Scandex Textile Industries Ltd.

31 December 2023

2. Observations

Column Layout (Building 1 – West Part)

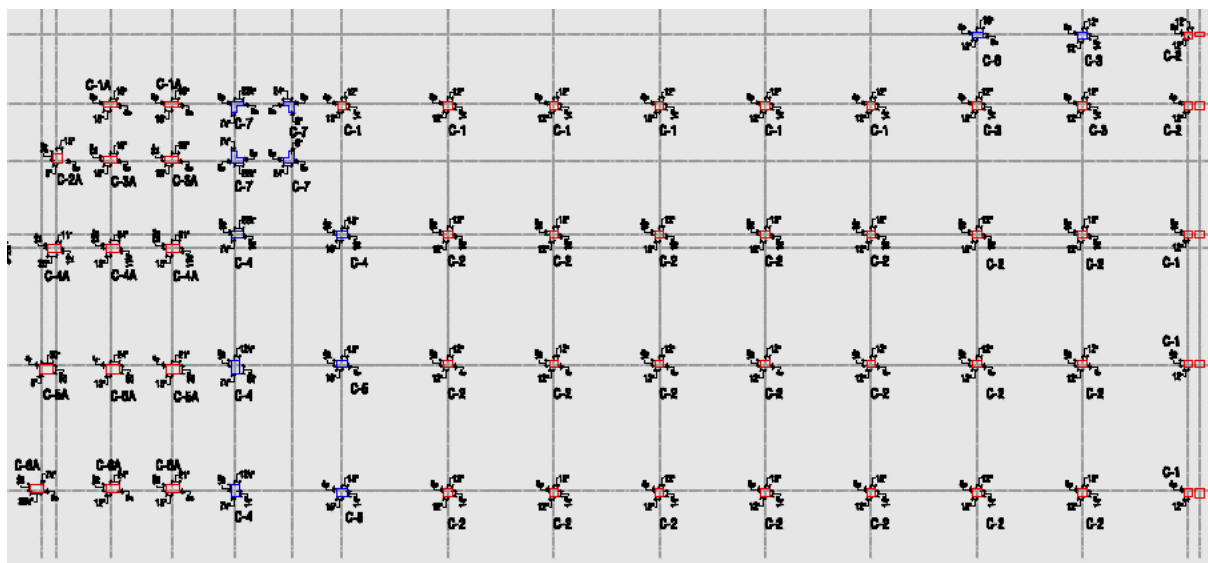
Observation 1: Column stressed above normal design limit. (Building 1)

Description: Cursory calculation indicates that interior columns are stressed above the normal design limit considering 3kPa live load and minimum concrete strength (2370 psi) based on aggregate type (available test reports are insufficient to meet the evaluation and acceptance criteria of BNBC). The building engineer is required to carry out Detail Engineering Assessment (DEA) to review the design, loads and column stress based on in-situ material strength and floor live loads.

Observation	Action Plan	Timeline
Column stressed above normal design limit. (Building 1)	As part of Detailed Engineering Assessment (DEA), the building engineer is required to review the design load, column stresses.	within 6 weeks
	Verify in situ concrete strength (100mm dia. cores from 4 columns) from the lower tier of the building.	within 6 weeks
	Produce and actively manage a loading plan for all floor plates within the factory considering column capacity.	within 6 weeks
	Carry out the suggested remedial works.	within 6 months
	Continue to implement final floor live load plan.	within 6 months
Lack of design documents. (Building 4)	The building engineer is required to prepare design documents (including as-built drawings, design report, load plan and material test reports) in compliance with section 1.9.1 (part-6, BNBC).	within 6 weeks
	Verify in situ concrete strength (100mm dia. cores from 4 columns) from the lower tier of the building.	within 6 weeks

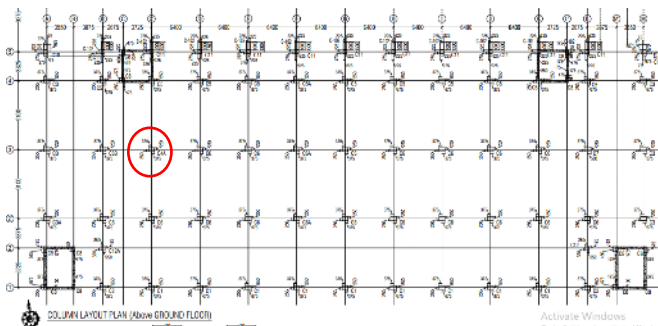
Observation-4: Lack of design documents (Building 2).

Description: As per BNBC, every building or structure designed shall have its design documents prepared in accordance with the provision of Section 1.9.1. During the inspection, the design report and soil test report was not available on site.

The building engineer is required to prepare a set of design documents including as built drawings and a design report based on in-situ material strength and software-based analysis which shall be prepared in compliance with section 1.9.1, part-6 of BNBC.

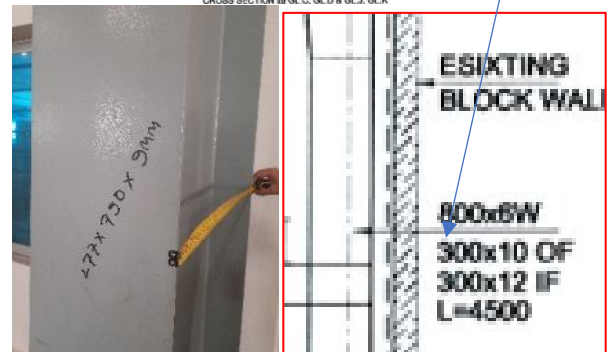
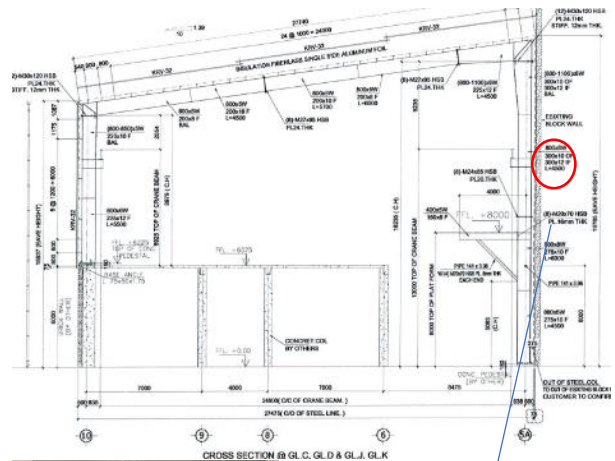
Observation-6: Discrepancies in the provided drawing (Building-3).

RC Column C4A (750X500) re-bar profile found by scanning 6/5 (18 no's) instead of 9/5 (24 no's)

Steel Column size observed F-277X9 W-790 instead of F-300X(10/12) W-800

Description: During the inspection, discrepancies were observed between the provided drawing and on-site conditions. RC column re-bar profile mismatch and steel column web-flange size & thickness mismatches were observed. The building engineer is required to survey the whole structure and update the drawing reflecting on-site condition.

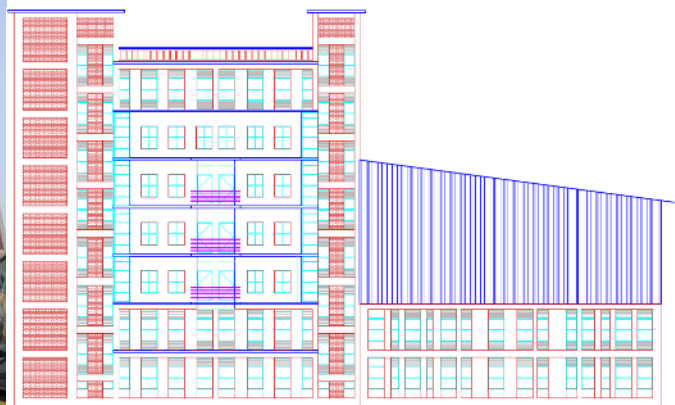
Observation-7: Lack of Design Report (Building-3).

Description: The design report was not prepared for the mentioned structure. The building engineer is required to prepare a design report following BNBC (part-6, section 1.9.1)
